Dear **Traffic Control Permit - RO-18185****Ipswich-Rosewood Road (304) ROSEWOOD****Ipswich-Rosewood Road (304) and Rosewood-Warrill View Road (305), Rosewood (between Keanes Rd and Reillys Rd)**

Thank you for your application, received 22 January 2015 requesting the Department of Transport and Main Roads' agreement to undertake temporary traffic control on Ipswich-Rosewood Road (304) and Rosewood-Warrill View Road (305), Rosewood (between Keanes Rd and Reillys Rd) for the purpose of removing and replacing power cables.

FW: Amended - New RO18185 - Permit Application for Ipswich Rosewood Rd
Rosewood

SHORT TERM - SHOULDER CLOSURE - TWO WAY ROAD www.invarion.com

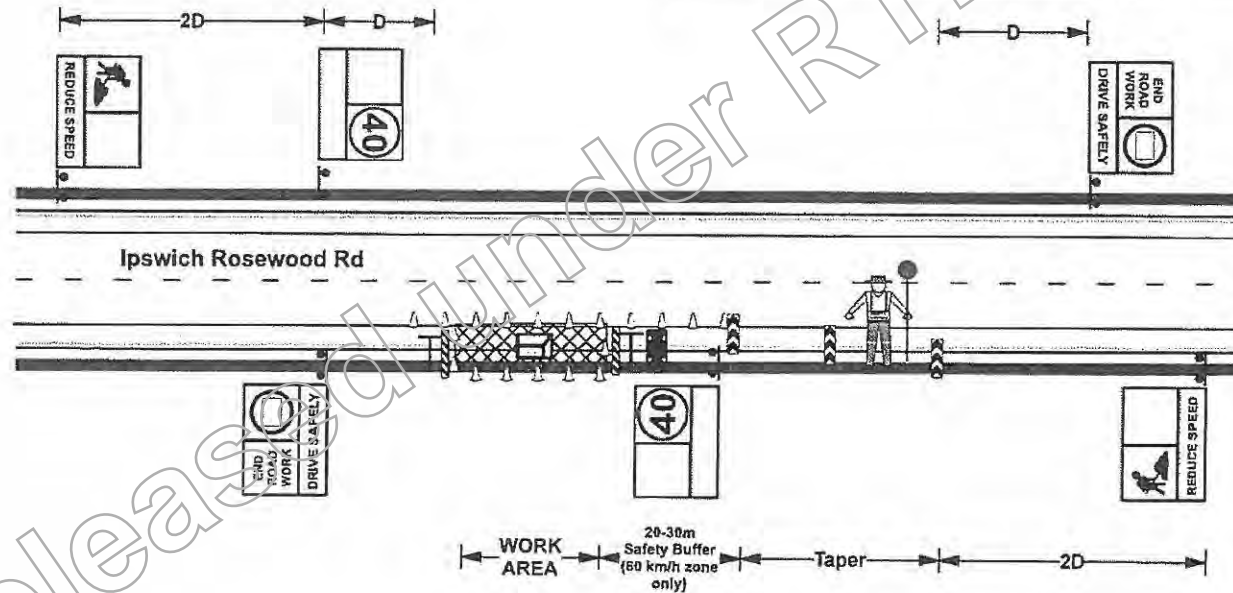
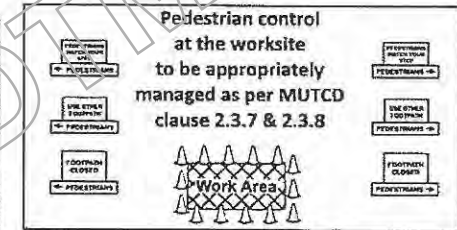
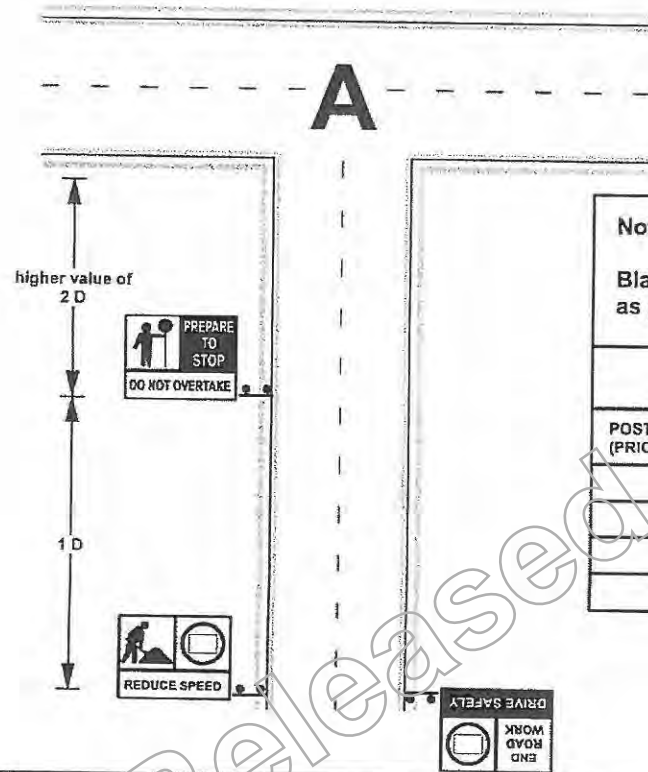
The distance between 'reduce speed' and end of taper should be 150-300m. Please use a 2D buffer zone for high speed approaching motorists. The distance D needs to be selected as per Part 3, MUTCD 2003 – sixth edition, depending on the posted speed of the section. Also please use the correct posted speed with the end of roadwork sign. The accesses to properties need to be maintained. The safety aspects of cyclists and pedestrians if any need to be maintained.

The distance between 'reduce speed' and end of taper should be 150-300m. Please use a 2D buffer zone for high speed approaching motorists. The distance D needs to be selected as per Part 3, MUTCD 2003 – sixth edition, depending on the posted speed of the section. Also please use the correct posted speed with the end of roadwork sign. The access to properties need to be maintained. The safety aspects of cyclists and pedestrians if any need to be maintained.
